1 December 2017

SECTION 96 (2) MODIFICATION APPLICATION – SSD 6376 BLOCK 11, CENTRAL PARK

This application has been prepared by Ethos Urban on behalf of Frasers Broadway Pty Ltd pursuant to section 96(2) of the *Environmental Planning and Assessment Act, 1979* (EP&A Act) to modify to modify State Significant Development Application SSD 6376 relating to Block 11, Central Park.

Figure 1-Location of previously approved plant room (shown in green) to Level 13

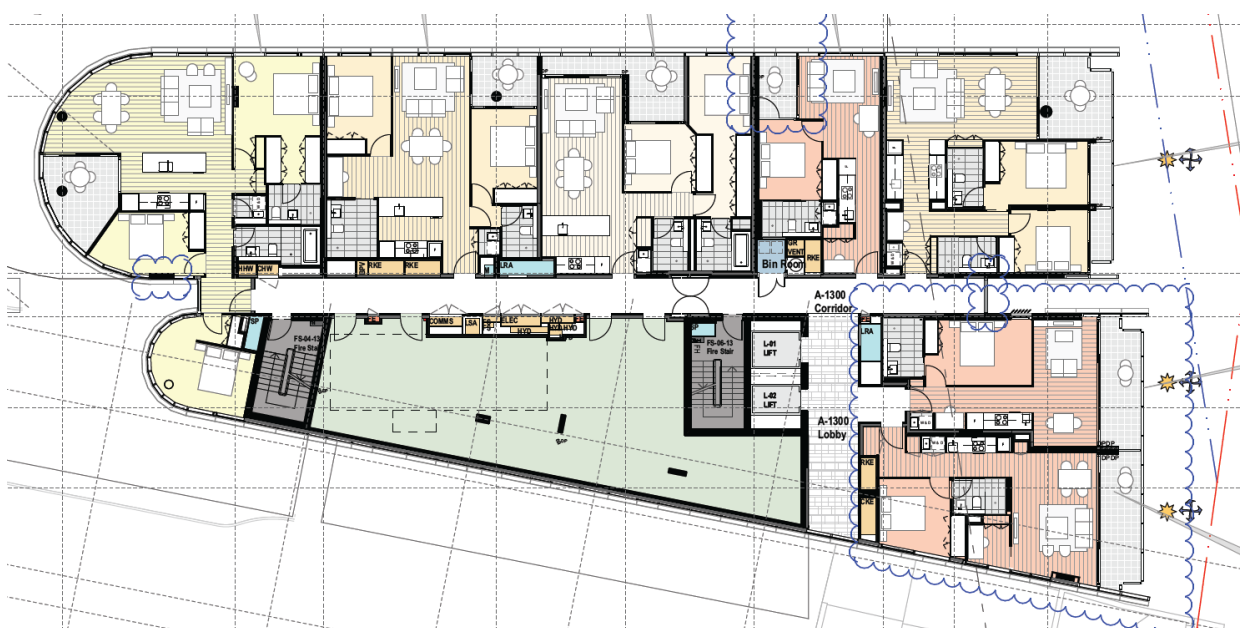
Design development for the building provided an opportunity for these areas to be connected to the precinct's central thermal plant for energy efficient heating and cooling, and this option has been pursued. Accordingly, a large portion of plant room on Level 13 (See **Figure 1**) is no longer required for mechanical plant, and is proposed to be replaced with dwellings. A small portion of the plant room is maintained for hydraulic plant.

The proposal seeks approval for the inclusion of 2 x one bedroom units on the southern elevation of Level 13, in place of the plant room, no longer required to be maintained within the development. The dwellings are accessed via the double lift core on level 13.

Proposed apartment E-1308 is 53sqm internally with a 7sqm balcony. Apartment E-1308 is similar to the previously approved apartments directly below on L10-L12.

Proposed apartment E-1309 is 50sqm internally with a 6sqm balcony. Both apartments have been designed in accordance with the Apartment Design Guide and SEPP 65.

Figure 3- Proposed retail signage to ground floor – northern elevation looking south down Kensington Street

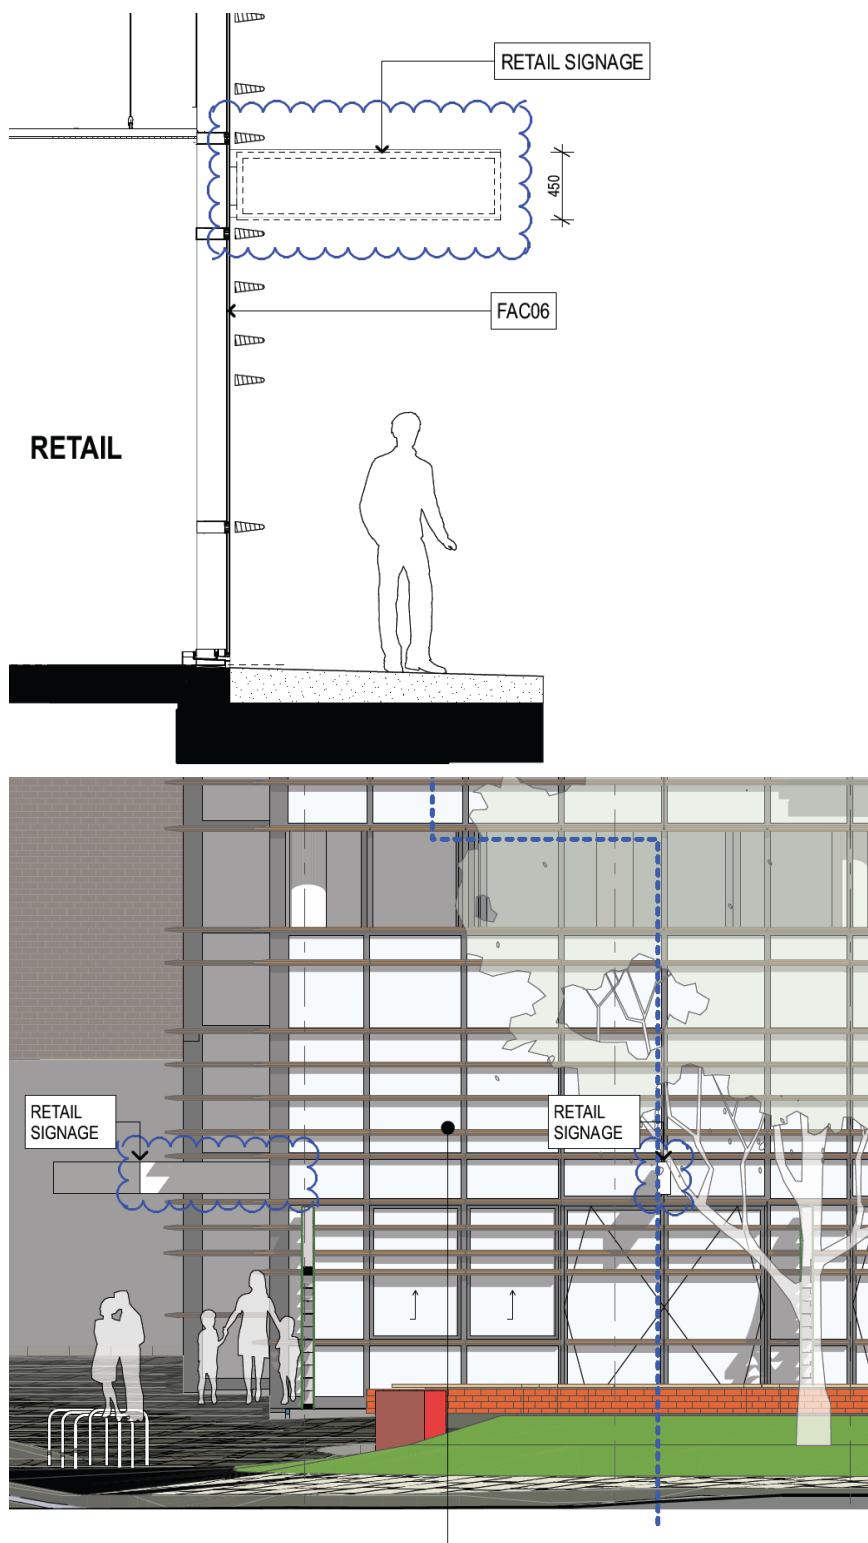
The modification seeks to include a projecting wall sign above the ground level entry of each of the five retail tenancies. As shown in **Figure 3**, the signage will consist of a light box, fixed to retail façade. The signage will have a width of 1750mm and depth of approximately 450mm.
